Oakley City Planning Commission Staff Report

CONCEPTUAL PLAT – River Haven Subdivision/Master Planned Development Applicant: Trevor Williams

To: Oakley City Planning Commission
From: Stephanie Woolstenhulme, City Planner
Date of Meeting: March 29, 2023
Type of Item: Conceptual Plat – Possible Action
Process: Administrative Review

1. Conceptual Plat
2. Architectural Design
3. Exterior Materials
4. Community Features

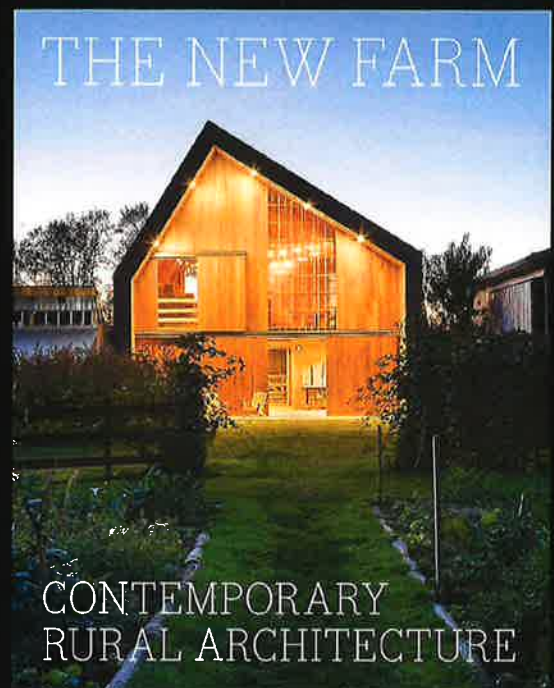
CITY PUBLIC WORKS COMMENTS – forthcoming as part of the preliminary plat, but access to City water on West side of Millrace Road (6" line) and City Sewer on East side of Millrace Road. Sewer will need to be evaluated for appropriate slope.

1. Possible exceptions to be made in a development agreement
 - a. Detached Accessory Dwelling Units (ADU)
 - b. .25 (or less?) acre lot for affordable housing obligation
 - c. No secondary access to prevent Wetland mitigation/disturb.
2. Wastewater plan
3. Irrigation water plan
 - a. Landscape plan
4. Trail system contribution

The Planning Commission is empowered to require additional and reasonable improvements to mitigate any detrimental effects to surrounding property and residents and to safeguard the general welfare of the future inhabitants of the subdivision.
